AIRPORT TERMINAL APRON

CHANGE ORDER NO: 3

Justification/Reason: To reconcile quantities in the contract to actual quantities used during construction; and to provide for P-501 Bonus Payments.

CHANGE ORDER # 3 - 0318ADDON

THICKENED EDGE NON-REINFORCED PAVEMENT

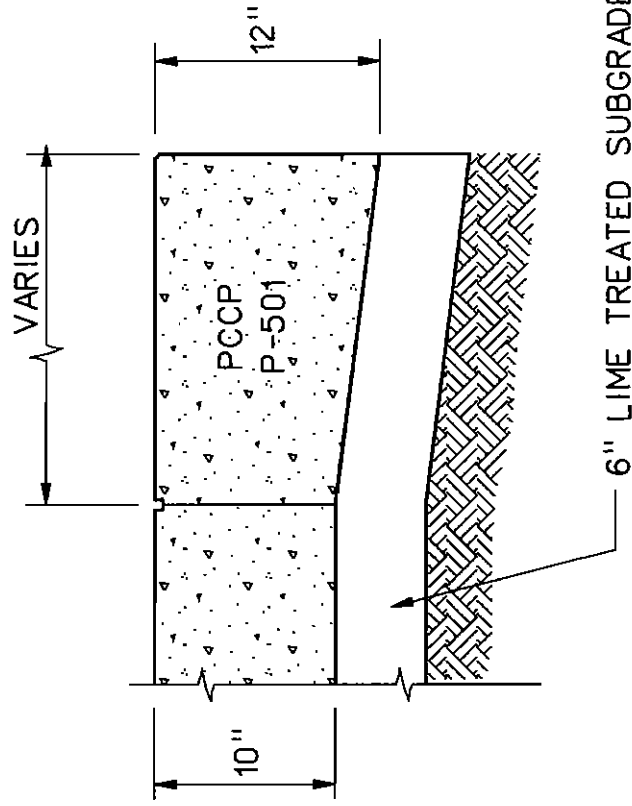
Pavement Design Change for Hangars A and B, Addison Airport

Dry Unit Weight of Soil (lb/cf)	100	
Degree Days °F	200	
Soil Frost Code	Non-Frost	Subgrade k-value was not modified for frost
Frost Depth Penetration (in)	20.50	
k value on top of stabilized layer	59	
k value on top of subbase layer	20	
Original subgrade k value	20

DUAL WH-50		20	Design Life (years)
50000 lbs	Gross Aircraft Weight		
21,904	Equivalent Annual Departures

Change Order #2

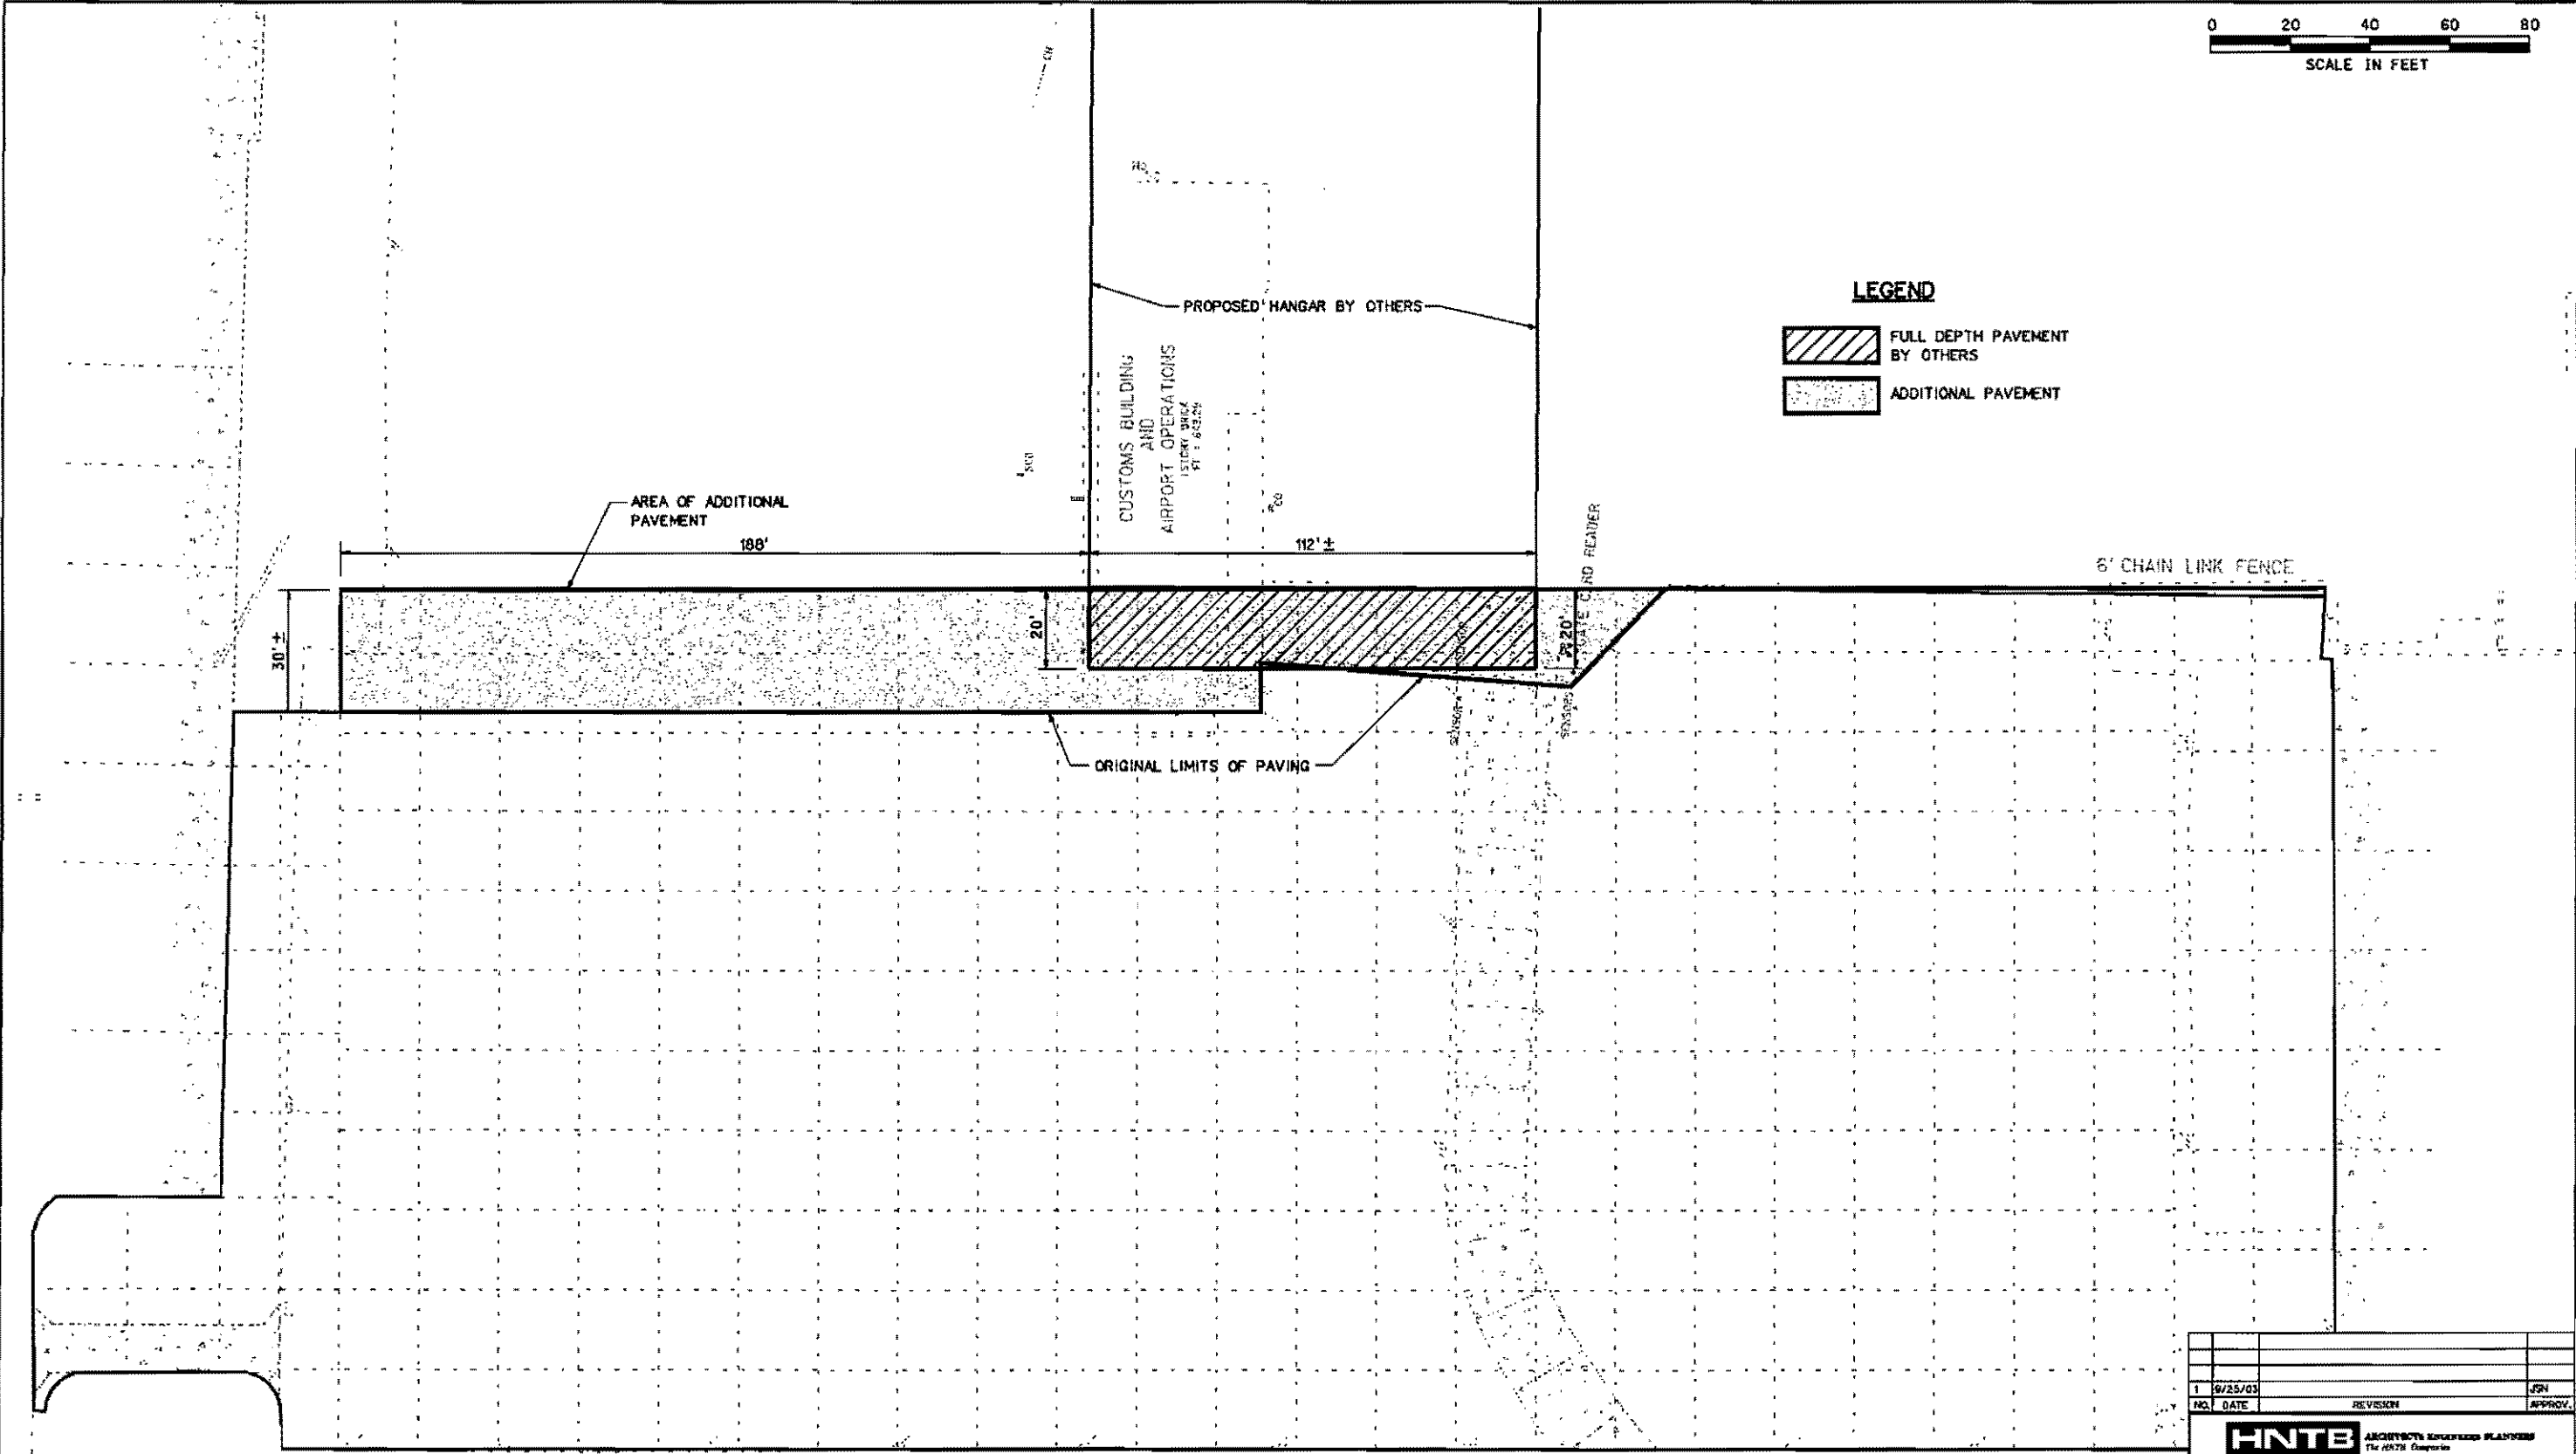
TIE-DOWN SOUTH

34 spaces

HANGAR 'C' GRADING,
DRAINAGE AND SW3P PLAN

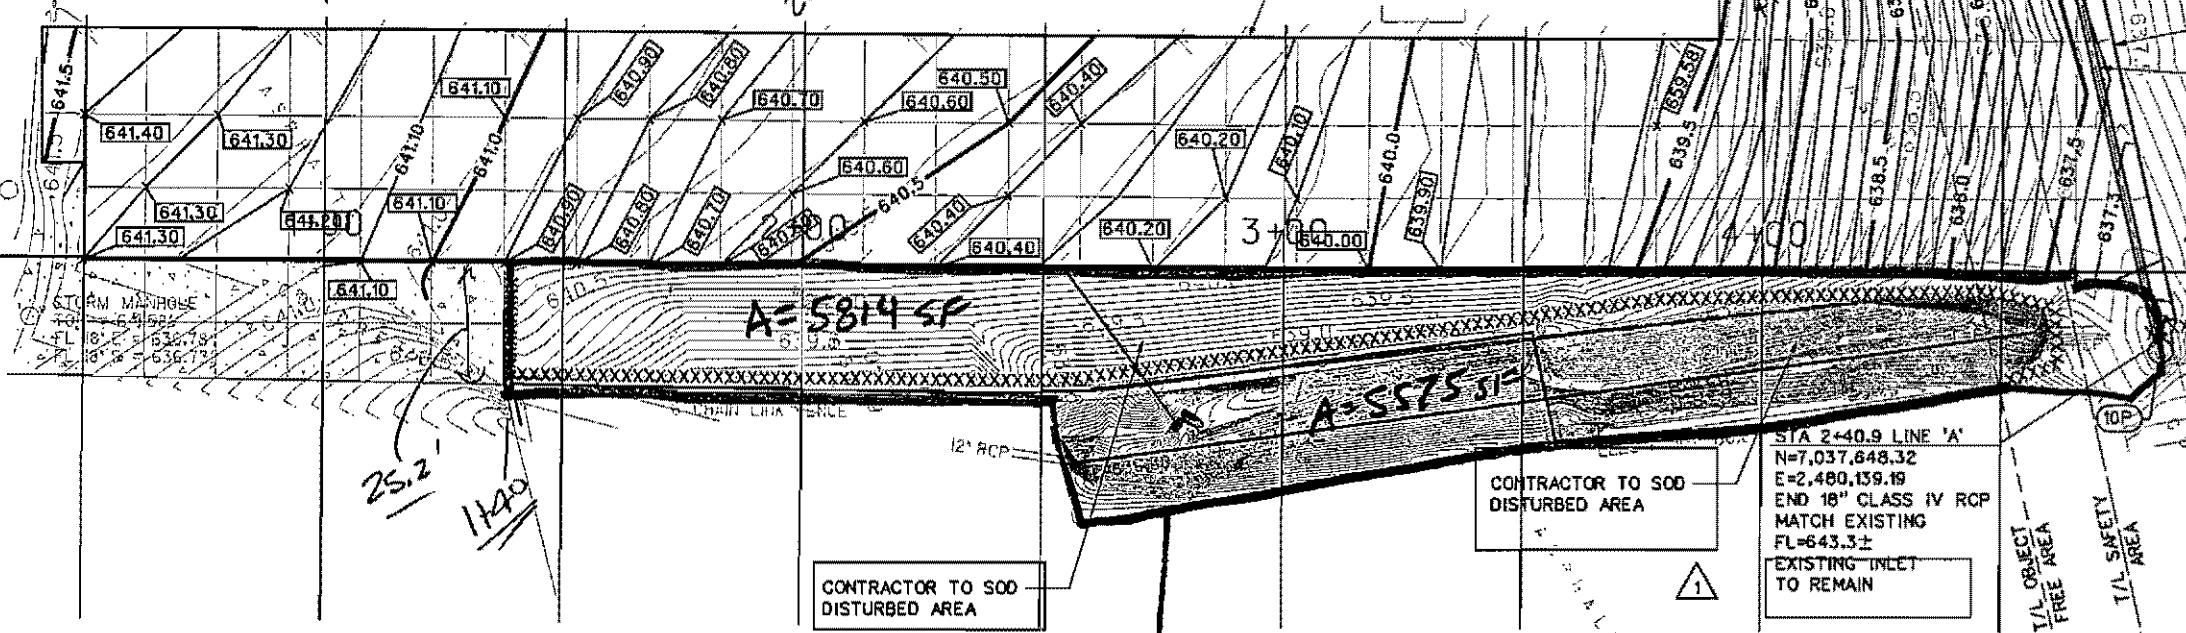
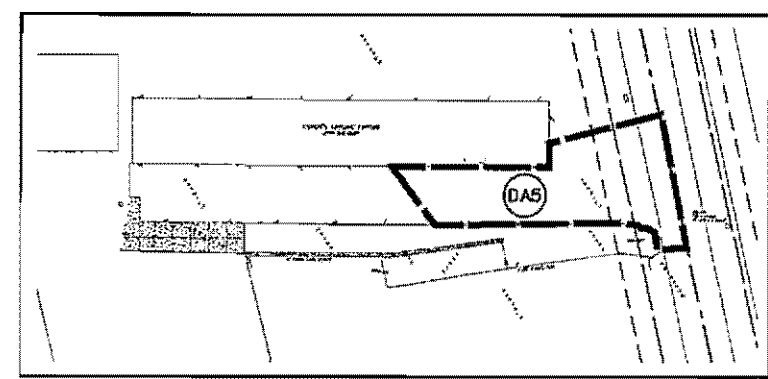
NO.	DATE	REVISION	APPROV.
1	9/25/03	ADDED SODDING NOTE, MODIFIED DRAINAGE NOTE	JSN
